UNITED STATES PATENT AND TRADEMARK OFFICE

APPLICATION NO.	FILING DATE	FIRST NAMED INVENTOR	ATTORNEY DOCKET NO.	CONFIRMATION NO.
10/634,257	08/05/2003	Masami Tamura	4041J-000745	3814
27572	7590	12/14/2005		
HARNESS, DICKEY & PIERCE, P.L.C. P.O. BOX 828 BLOOMFIELD HILLS, MI 48303			EXAMINER KLEBE, GERALD B	
			ART UNIT	PAPER NUMBER
			3618

Office Action Summary	Application No. 10/634,257	Applicant(s) TAMURA ET AL.	
	Examiner Gerald B. Klebe	Art Unit 3618

DETAILED ACTION

FIG. 3

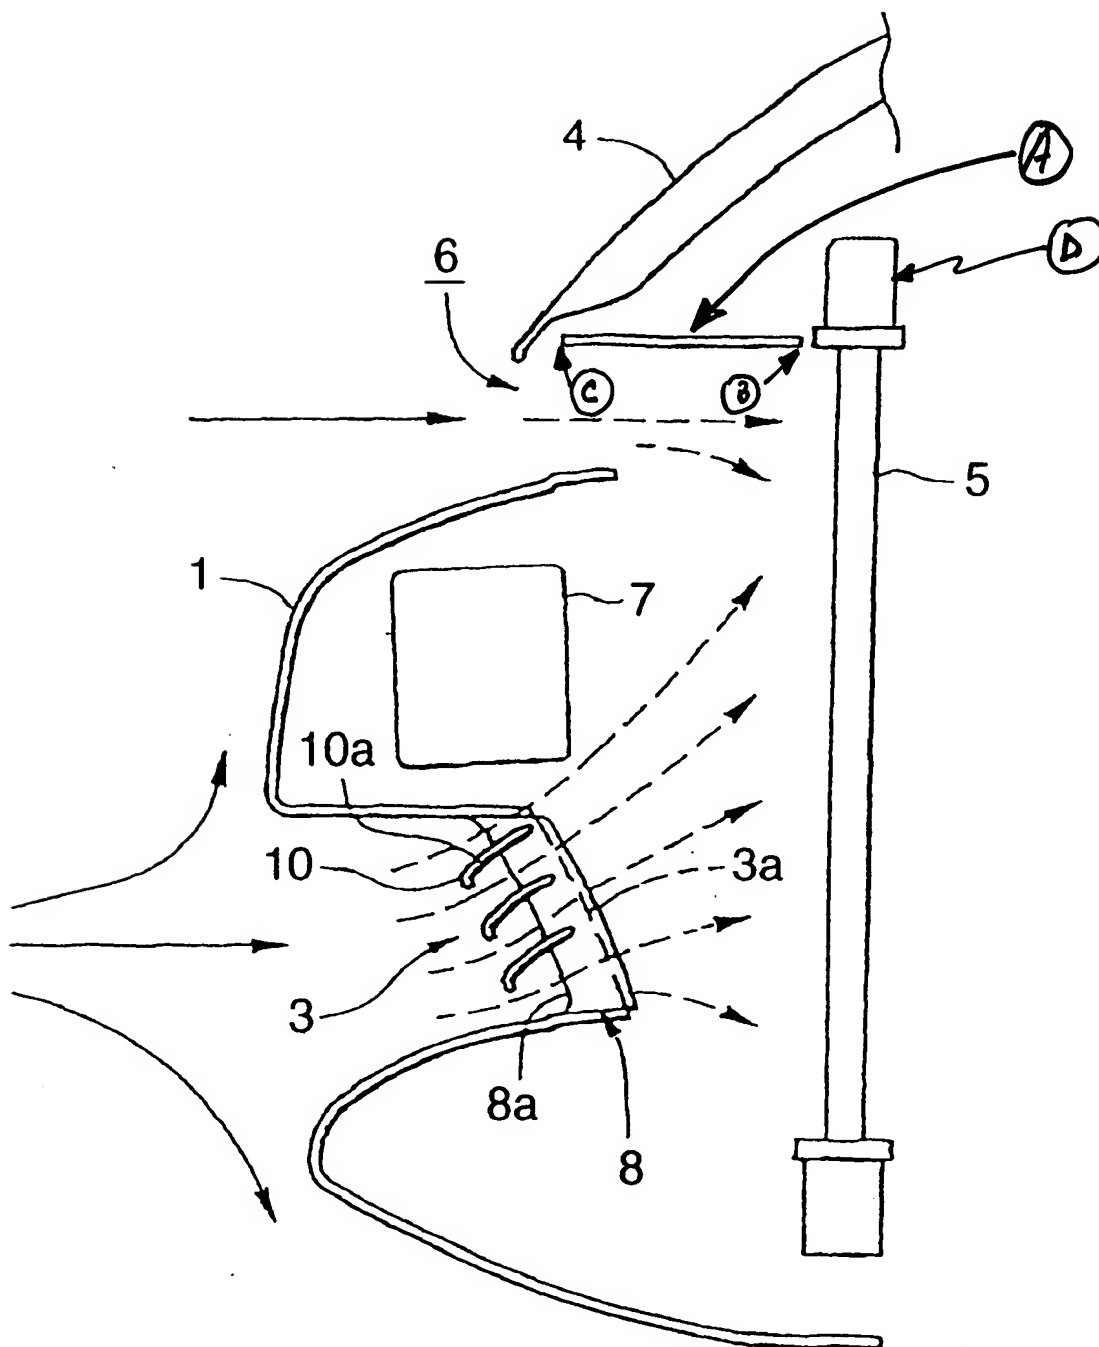
Ohkura et al. discloses a front end structure of a vehicle (refer Fig 1) comprising: (**re: claim 11**) a grill (Fig 3; comprised of items 1, 3, 3a, and 8a) provided at a front end of the vehicle, wherein the grill defines an opening (6) through which air is introduced; a heat exchanger located adjacent to the grill in an engine compartment (Fig 8, item 11; see also Fig 12), wherein the heat exchanger has a core portion (5) for performing heat exchange between the air and a fluid flowing inside of the core portion, and a tank (item "D"; **refer to the examiner's marked-up version of Fig 3 attached hereto** to the Office Action) connected to an end of the core portion; and a cover member (examiner's indicated item "A" on the marked-up version of

Fig 3 attached hereto; item "A" is considered to be a sectional view of the front upper cross member of the vehicle shown in Fig. 7) including a wall (taken as the bottom, or underside of item "A"), wherein the wall is disposed such that its first end ("B") is adjacent to a boundary between the core portion (5) and the tank ("D") and its second end ("C"), which is opposite to the first end, is adjacent to an end of the opening (6), so that the cover member directs the air passing through the grill toward the core portion and restricts foreign materials from [adhering to] impinging on (examiner's interpretation) the tank (as indicated in the figure 3 by the arrow(s) depicting the airflow through 6 and onto the core portion 5 of the heat exchanger); and (re: claim 15) wherein the tank ("D") is connected to a top end of the core portion (5) and the second end ("C") of the wall is adjacent to a top end of the opening (6).

Ohkura et al. ("Ohkura") teaches a cover structure (refer Fig 3; see Examiner's marked-up copy of figure 3 of the reference found attached to this Office Action) for a heat exchanger located adjacent to an opening (item 6) through which air is introduced and which has a core portion (item 5) for performing heat exchange and a tank (labeled "D" by the examiner) connected to the core portion, the cover structure comprising: (re: claim 1) a cover member

(labeled as item “A” in the attached examiner’s mark-up of Fig 3 of the reference; item “A” is considered to be the front upper cross member of the vehicle, shown in Fig 7) including a wall (taken as the bottom side of “A”) that has a first end (labeled as “B” by the examiner) and a second end (labeled as “C” by the examiner) opposite to each other, wherein the cover member (“A”) is disposed such that the first end (“B”) is adjacent a boundary between the core portion (5) and the tank (labeled as “D”) and the second end (“C”) is adjacent to the opening (6) so that the wall (the bottom side of “A”) directs the air passing through the opening toward the core portion (as indicated by the arrow(s) in the figure which represent the direction of airflow through opening (6) below the cover member (“A”) as the air impacts the core portion (5) of the heat exchanger below the tank (“D”); and (**re: claim 8**) wherein the tank (“D”) is located on the top of the core portion (5) and the second end of the wall (“C”) is located adjacent to a top end of the opening (6); and (**re: claim 10**) wherein the cover member (“A”) is disposed such that the wall restricts foreign materials passing through the opening (6) from [adhering to] impinging on (**examiner’s interpretation**) the tank.

Therefore, it would have been obvious to one of ordinary skill in the art at the time the instant invention was made to have supported the upper portion of the heat exchanger of Ohkura from the front upper cross member (taken as item "A" in the examiner's marked-up version of Fig 3 of the reference) in accordance with the teachings of Ide et al. in order to secure the upper portion of the heat exchanger in the vehicle engine compartment as an obvious engineering choice based upon the common knowledge in the art.

RE: S/N 10/634257. EXAMINER'S MARK-UP OF FIGURE 3 OF USPAT 6,405,819B1 IN PARTIAL EXPLANATION OF REJECTIONS FOUND IN OFFICE ACTION DATED 8 DEC 2005.
